Re: Catawba Nuclear Station
Docket Nos. 50-413 and 50-414

Ms. Elinor G. Adensam's letter of April 10, 1984 requested confirmation of implementation of TMI Item II.F.2, Instrumentation for Inadequate Core Cooling. The following summarizes the status of each system.

Response to TMI Concerns

Incore Thermocouple System

INCORE THERMOCOUPLE
SYSTEM CONFIGURATION
CATAWBA NUCLEAR STATION

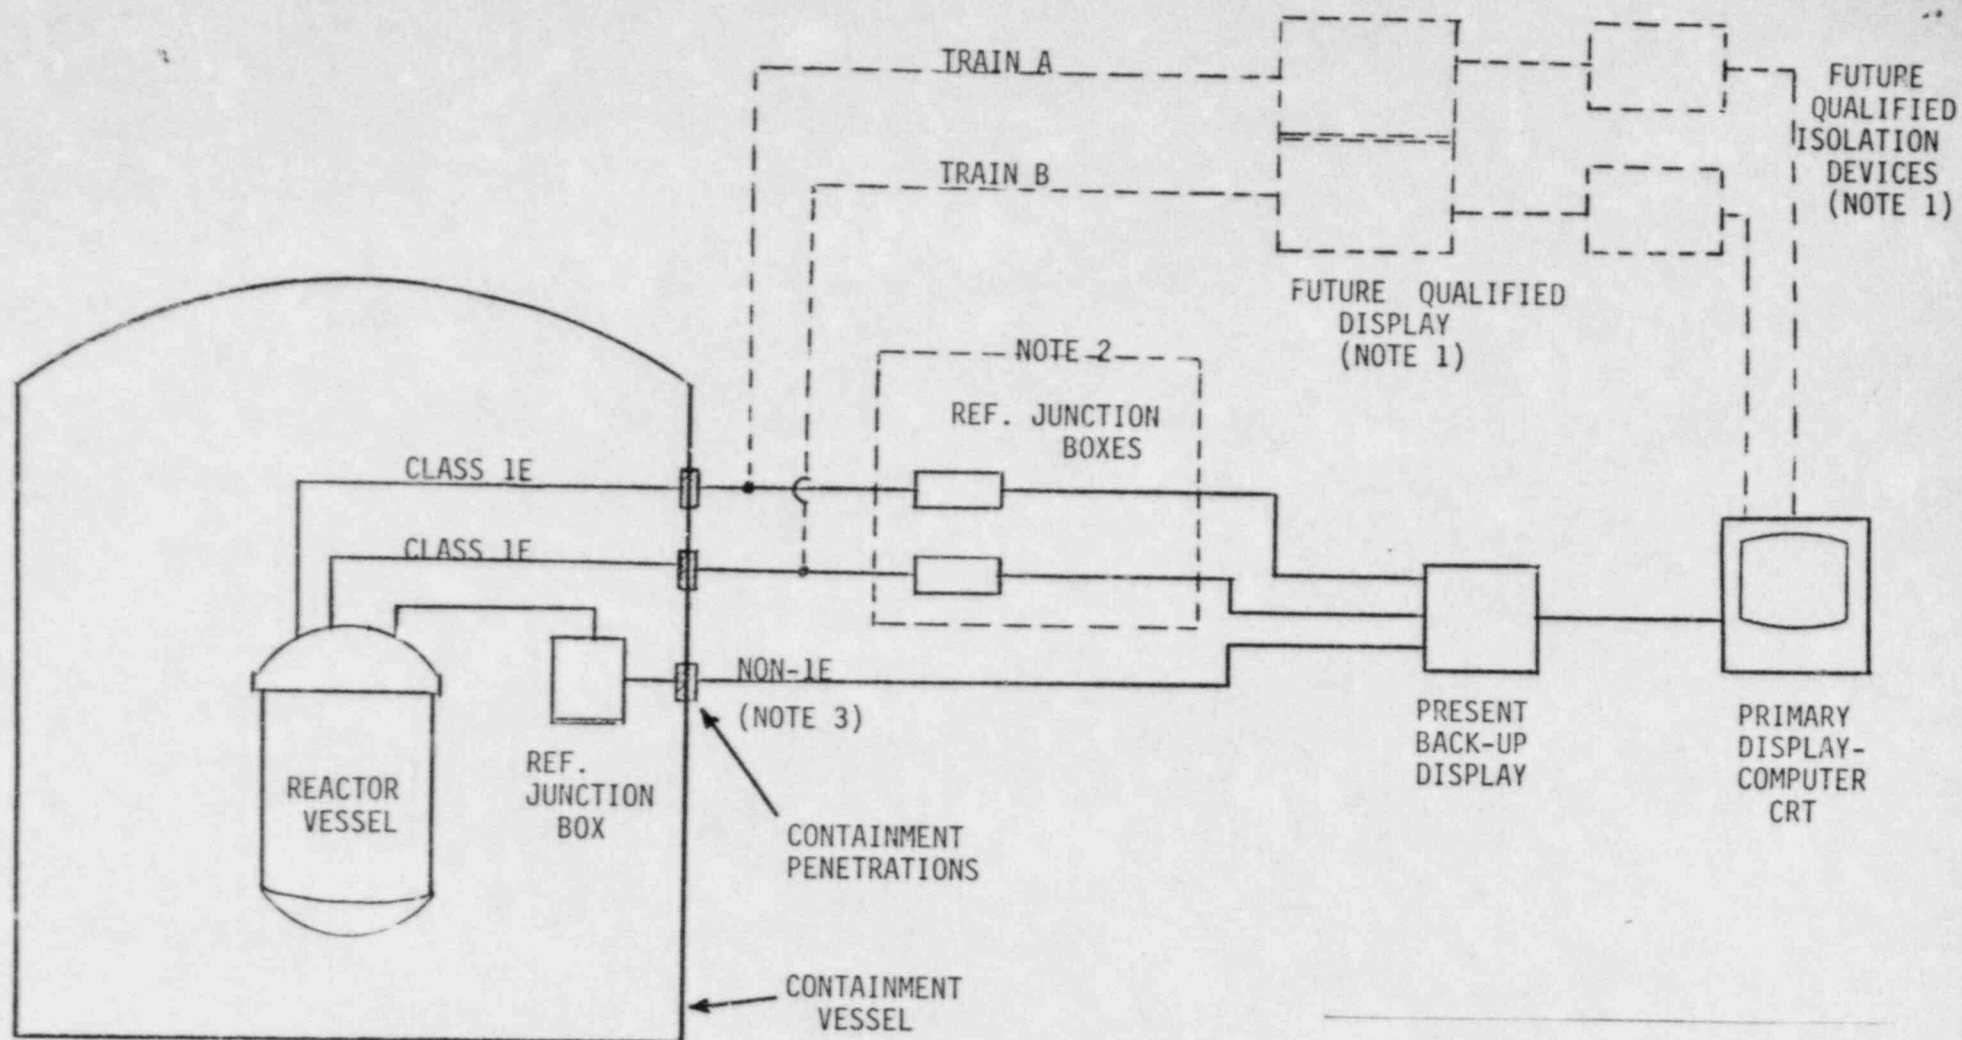
The present incore T/C system will be upgraded in the following manner. From outside of containment the non-safety thermocouple cabling will not be altered. However, the class 1E T/C cables will be cabled to a class 1E backup display directly from the T/C penetrations. These T/C's will be cabled to the primary display using qualified isolation devices. The backup display will be selected as part of the ongoing control board review. A description of the upgraded display will be provided by December 31, 1984.

NOTE 1: The dotted system components and cables will be added during the upgrade of the incore thermocouple system.

NOTE 2: These components will be removed during the upgrade of the system.

NOTE 3: These portions of the system will retain their present configuration after the upgrade.
